## Change of the crossbar screw on Agile

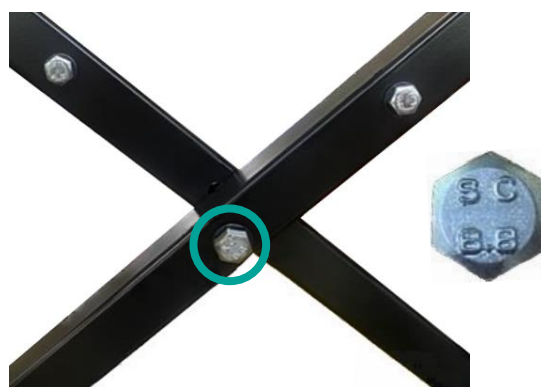
- ✓ To improve the strength of the crossbar screw, Karma has changed the screw grades and colour from metric class 4.8 black to class 8.8 silver-white. The new screw has also added a head marking "S C 8.8" as the photo shows.
- ✓ The updated version was implemented by the batch of serial no. HM22-039490.
- ✓ The updated version was implemented on Agile.
- ✓ The updated version is backward compatible with the existing one.
